PLANNERS AND ENGINEERS COLLABORATIVE
 WE PROVIDE SOLUTIONS™
 300 West Sandtown Road
 A MASTER PLANNED RESIDENTIAL SINGLE FAMILY COMMUNITY
 BLAKE PROJECTS INC.
 1324 JACKSON CREEK DRIVE
 MARIETTA, GEORGIA 30068
 CONTACT: BRUCE GOODMAN
 PHONE: 770-841-9457

REZONING SITE PLAN
 SCALE 1" = 60'
 DATE April 12, 2013
 PROJECT 13072.00

PETITION NO: Z-33
HEARING DATE (PC): 07-08-13
HEARING DATE (BOC): 07-16-13
PRESENT ZONING: R-20 and R-30
PROPOSED ZONING: R-20/OSC
PROPOSED USE: Single-Family Detached
Residential Subdivision
SIZE OF TRACT: 20.91 acres
DISTRICT: 19, 20
LAND LOT(S): 22, 23, 331, 332
PARCEL(S): 1, 3, 9, 25
TAXES: PAID X **DUE**
COMMISSION DISTRICT: 1

ZONING COMMENTS:

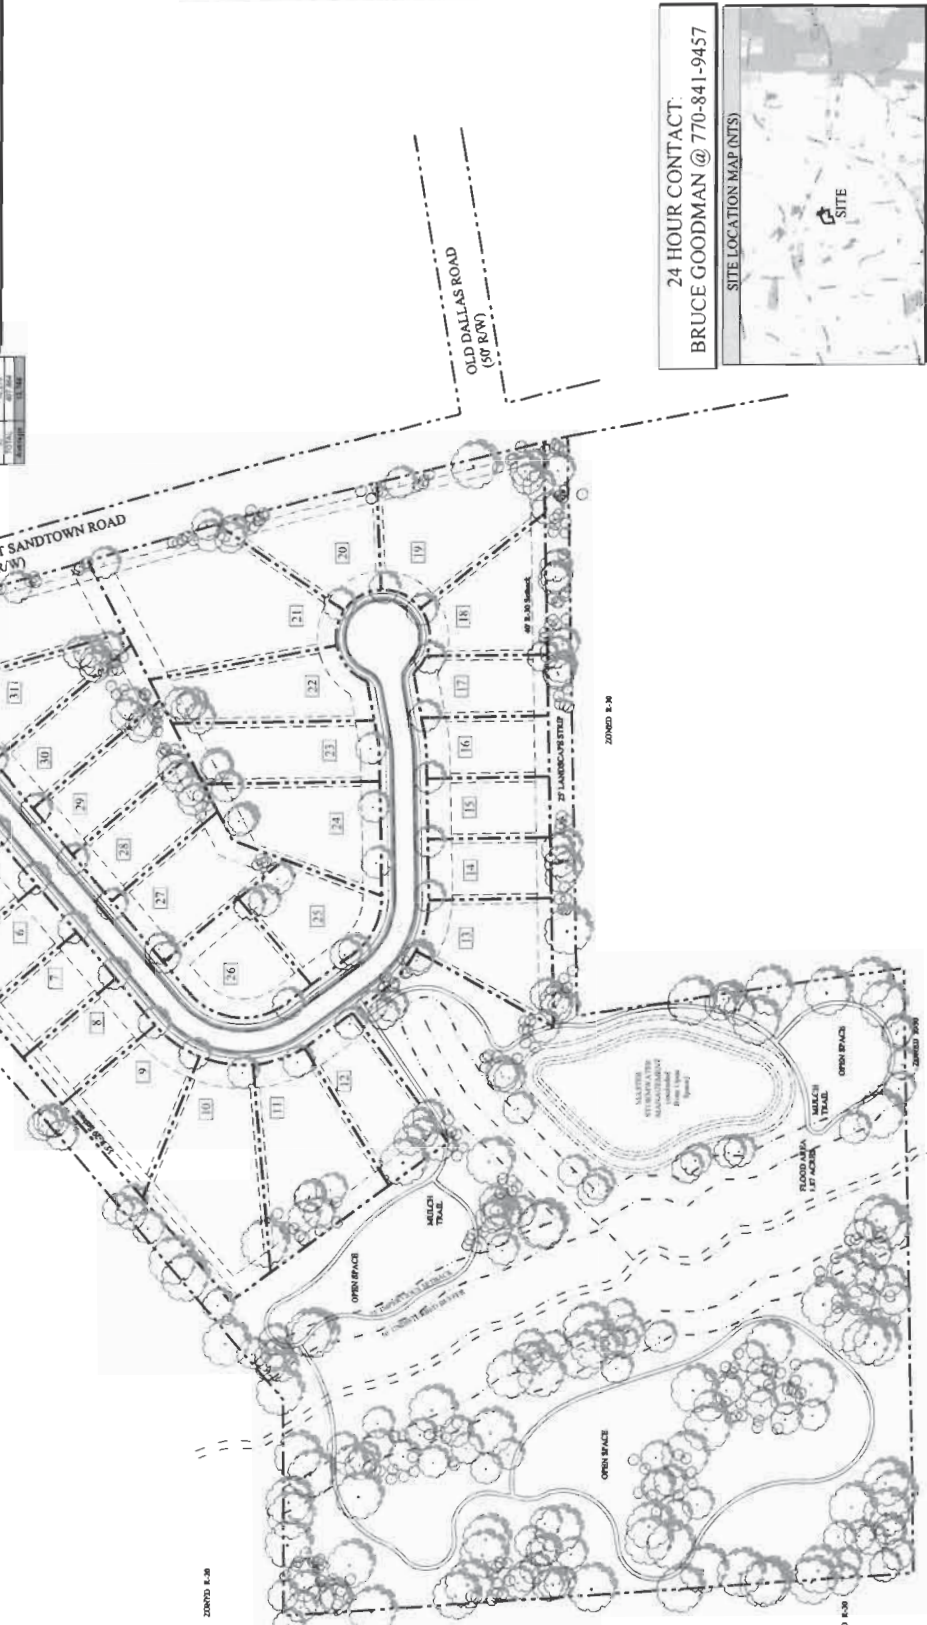
1. Precedent has been set that in this area of the county lots within OSC communities have not been smaller than 10,000 square feet. Staff recommends increasing lots 3 through 7 and 14 through 17 to greater than 10,000 square feet.

2. Applicant should incorporate larger lots to the exterior of development and design smaller lots to the interior.
3. As another form of privacy barrier staff recommends installing a 6' high green, black or brown chain link fence between the open space and lots 1 through 12 and 13 through 19.

4. For all lots contiguous to open space please include deed during sale of homes so that future lot owners are aware that commonly owned open space exists adjacent to their property and cannot be built on.

- Provide comprehensive hydrology/stormwater controls to include development of out parcels.
- Submit all proposed site improvements to Plan Review.
- Any **spring activity** uncovered must be addressed by a qualified geotechnical engineer (PE).
- Structural fill placed within the existing lake bed must be performed under the direction of a qualified registered Georgia geotechnical engineer (PE).
- Existing facility.
- Project must comply with the Water Quality requirements of the CWA-NPDES-NPS Permit and County Water Quality Ordinance.
- Water Quality/Quantity contributions of the existing lake/pond on site must be continued as baseline conditions into proposed project.
- Calculate and provide % impervious of project site.
- Revisit design; reduce pavement area to reduce runoff and pollution.

- No Stormwater controls shown _____
- Copy of survey is not current – Additional comments may be forthcoming when current site conditions are exposed.
- No site improvements showing on exhibit.

1. This site is located just west of West Sandtown Road on an unnamed tributary to Mud Creek. The entire site drains to creek which bisects the western half of the site. There is a small existing farm pond (~1/3 acre) located near the center of the site.
2. The proposed plan shows the elimination of the existing farm pond. The water quality benefit and storage effect of the existing pond must be recreated in the proposed stormwater management facility.
3. A footbridge across the creek is proposed to provide trail access to the open space area to the west of the stream. A hydraulic analysis will be required to provide an no-rise certification for this structure. No approach fill within the floodplain will be allowed.

West Sandtown Road is classified as a major collector and according to the available information the existing right-of-way does not meet the minimum requirements for this classification.

Recommend applicant consider entering into a development agreement pursuant of O.C.G.A. 36-71-13 for dedication of the following system improvements to mitigate traffic concerns: a) donation of right-of-way on the west side of West Sandtown Road, a minimum of 40' from the roadway centerline.

Recommend curb, gutter, and sidewalk for the West Sandtown Road frontage.

Recommend curb and gutter along both sides and sidewalk along one side of proposed development roadway.

Recommend a deceleration lane on West Sandtown Road for the entrance.

Recommend applicant verify that minimum intersection sight distance is available for West Sandtown Road access and if it is not, implement remedial measures, subject to the Department's approval, to achieve the minimum requirement of 500 feet.
